Duke Energy Ohio
Case No. 19-1471-EL-BLN
Staff Third Set of Data Requests
Date Received: April 2, 2020
STAFF-DR-03-002

Duke Energy Ohio
Case No. 19-1471-EL-BLN
Staff sECOND Set of Data Requests
Date Received: October 25, 2019
STAFF-DR-02-001

INDEX: F684			
	DESCRIPTION: CONSTRUCTION DRAWING			
DATE: 7/24/2019	LOCATION: HAMILTON CO, OH			
DRAWN: JAKE DAWN			ENGINEER: JAKE DAWN	
TRANSMISSION LINE ENGINEERING	CKD:	PAGE:	SCALE: NOTED	DWG NO: 28935640-1

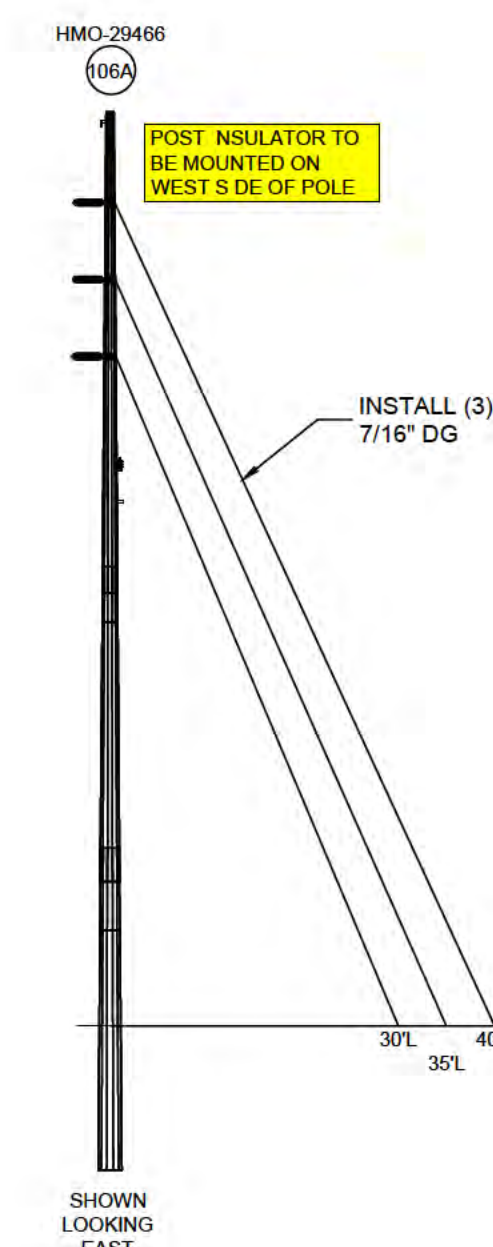
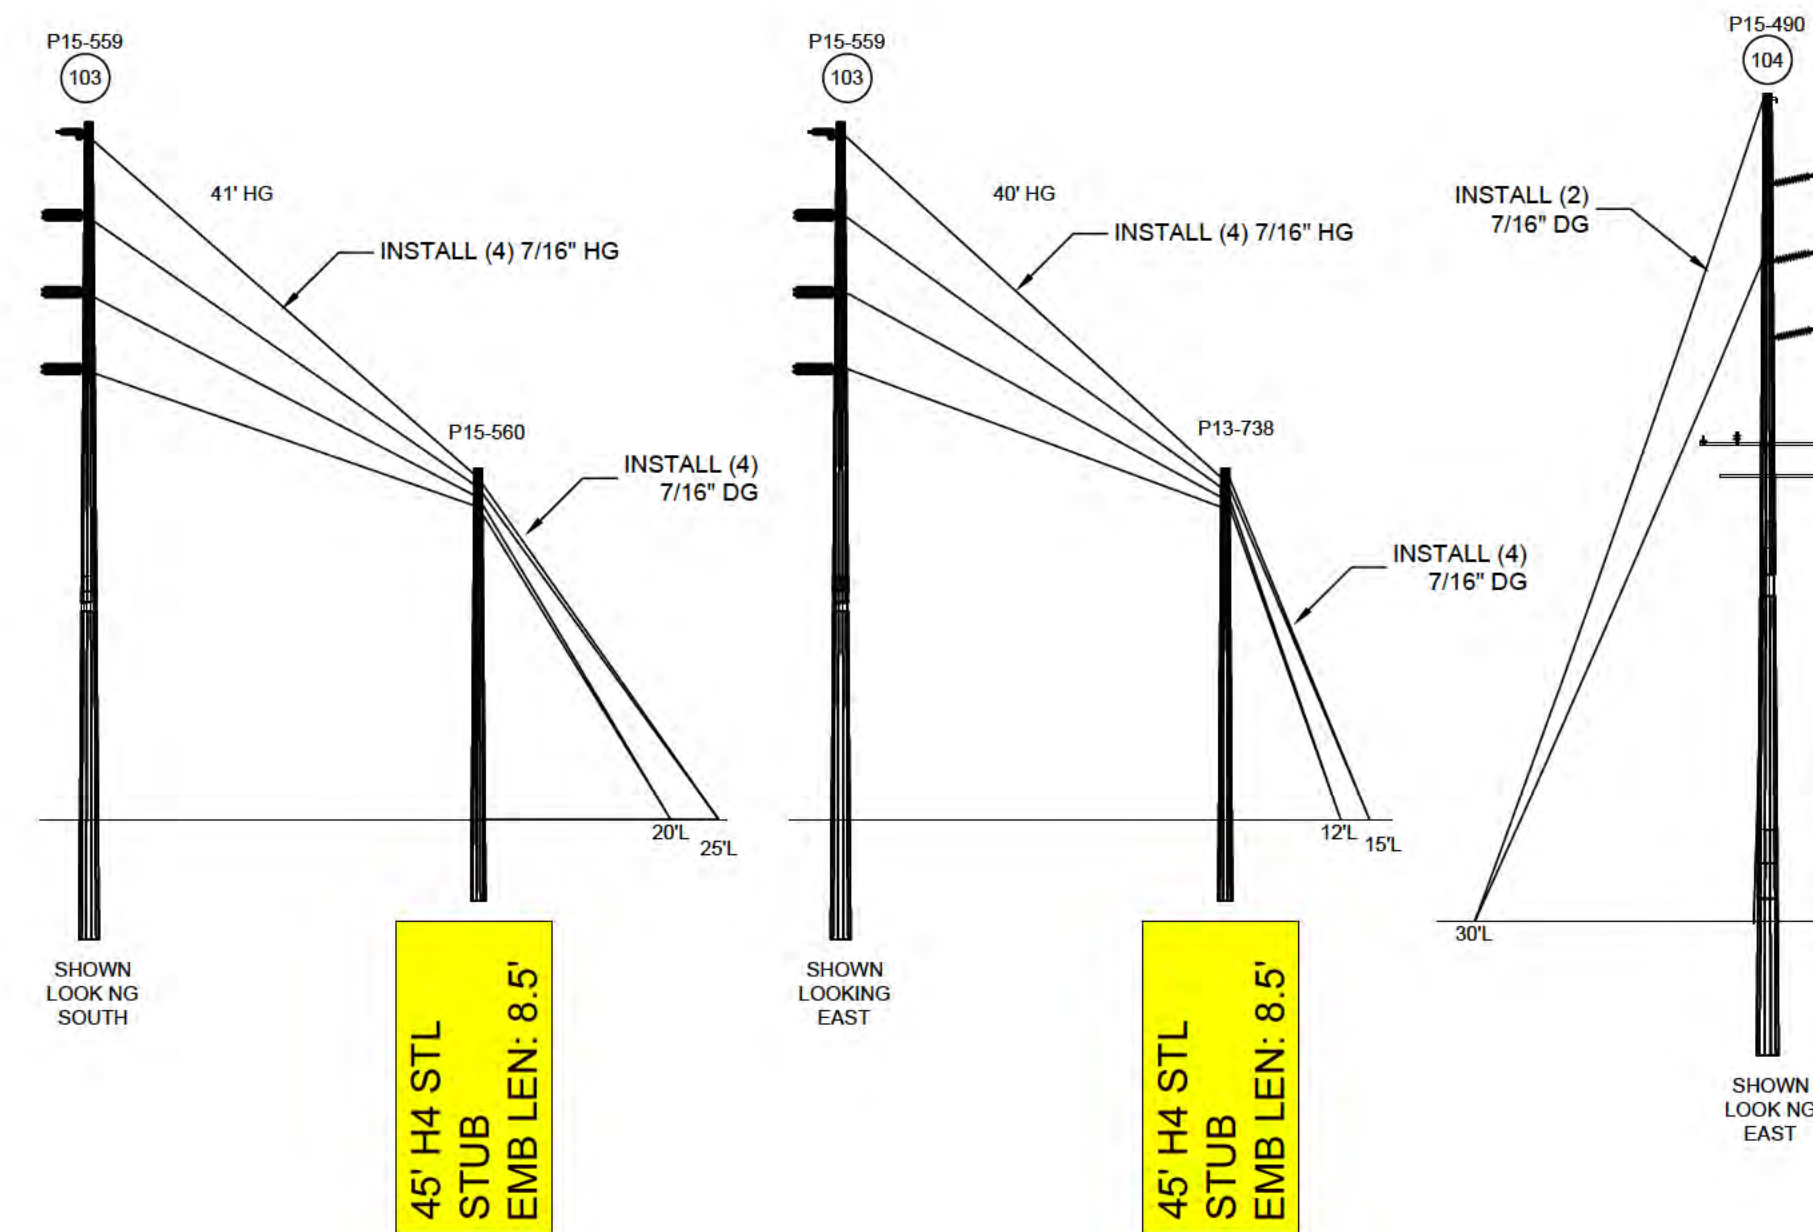
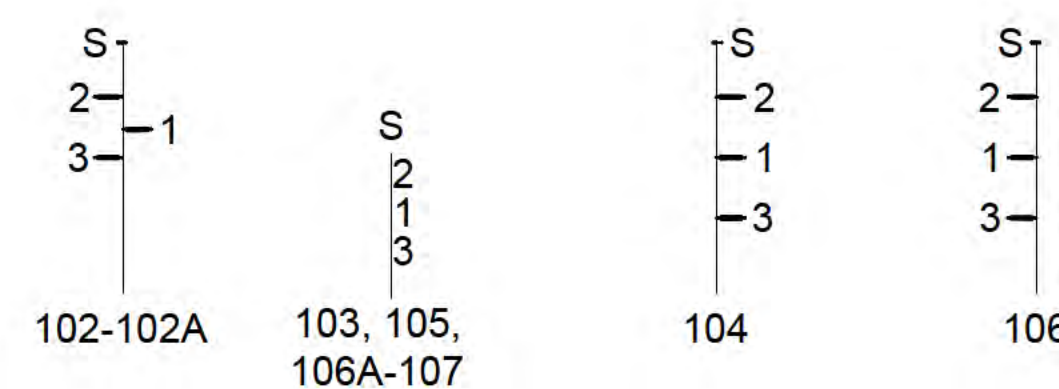
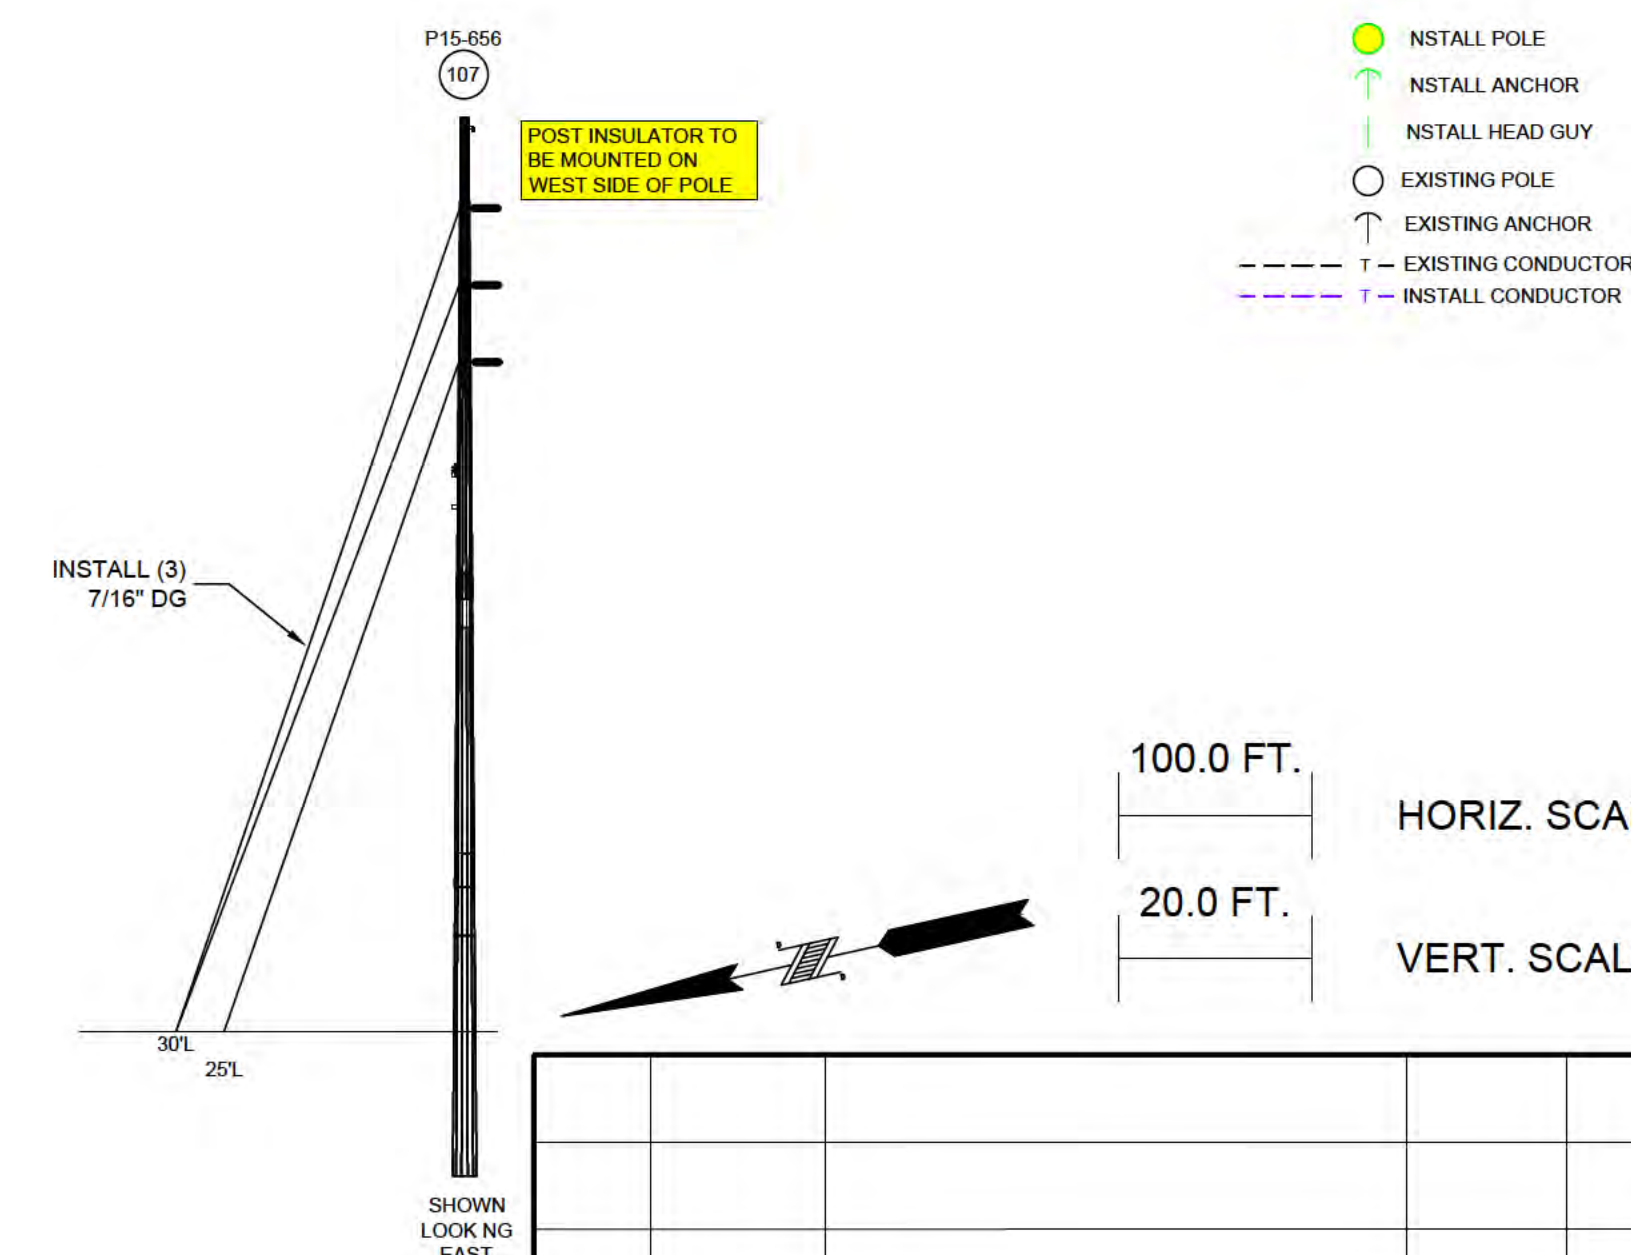
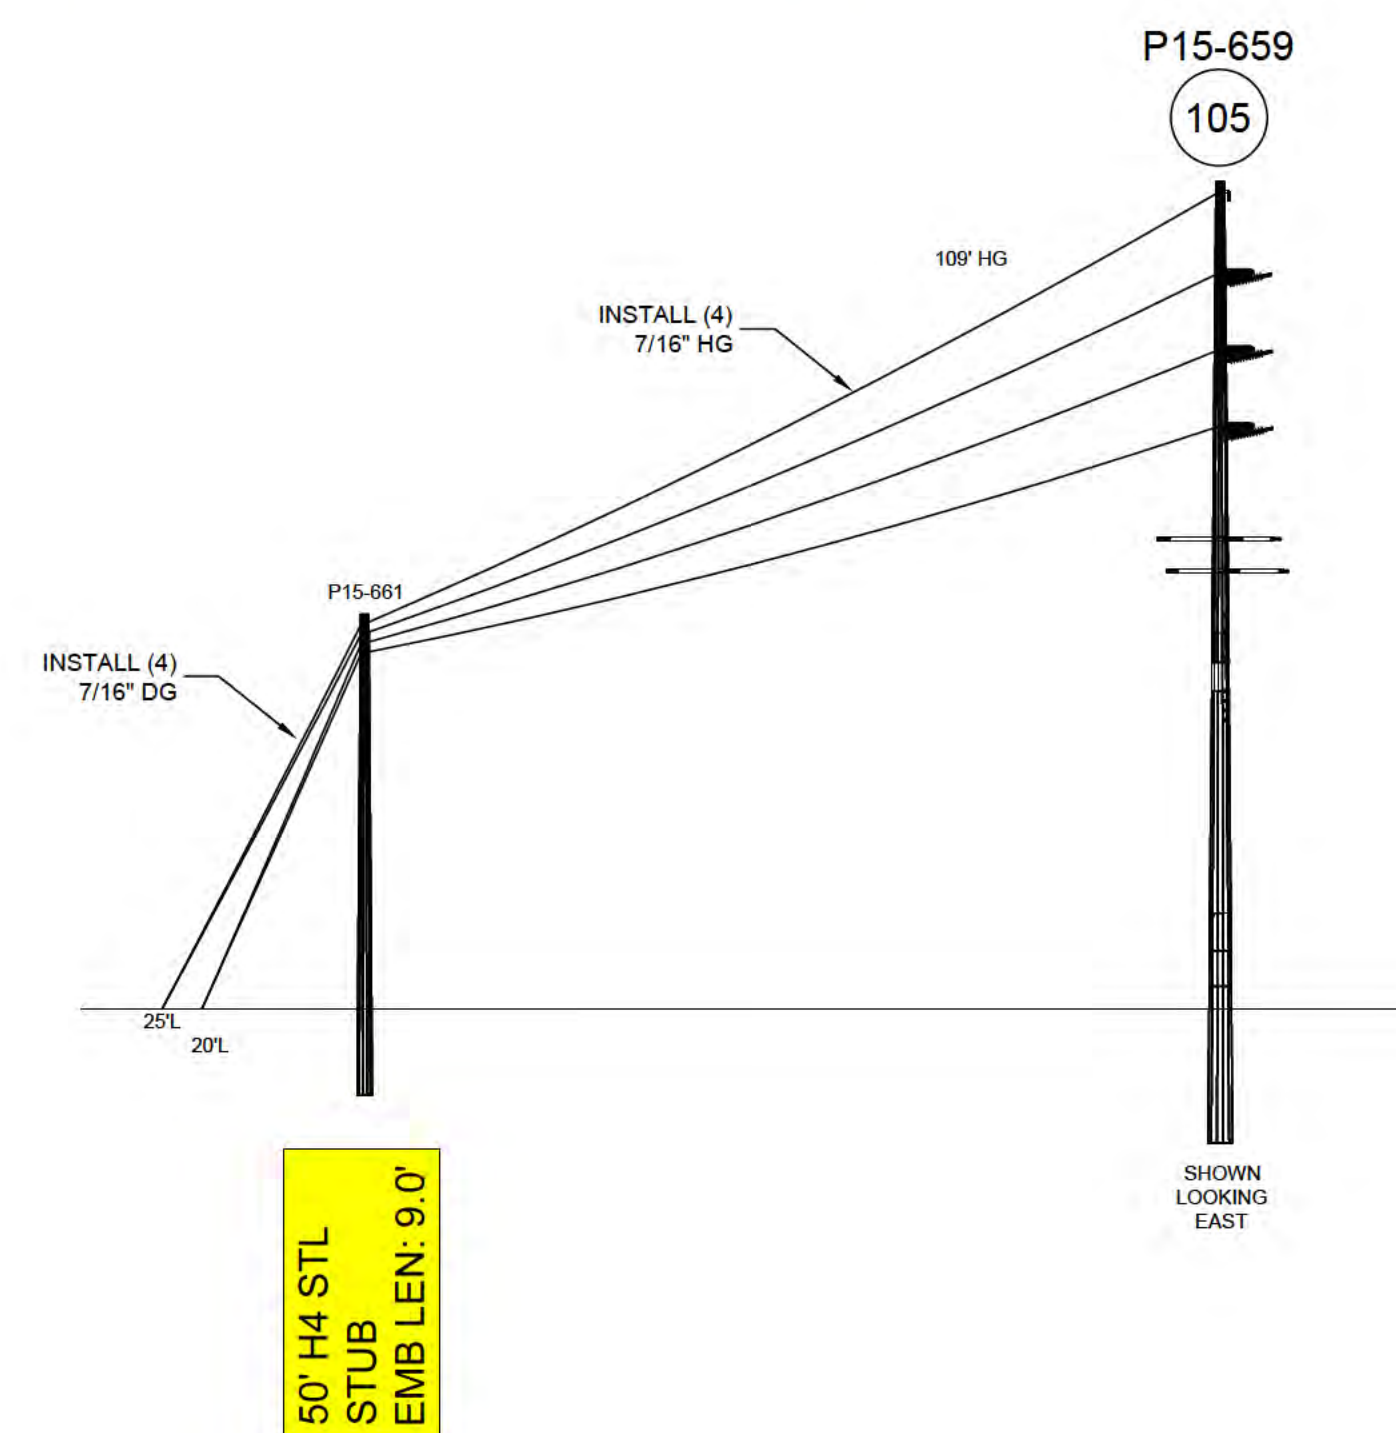
Please clarify the height of the new structures? The application states the heights of new structures ranges from 73 to 106 feet (46 total). Can you clarify this please, showing which height structures would be used in which locations?

Engineering drawings have been attached to show structure height.

Please see STAFF-DR-02-001 Attachment 1 through STAFF-DR-02-004.
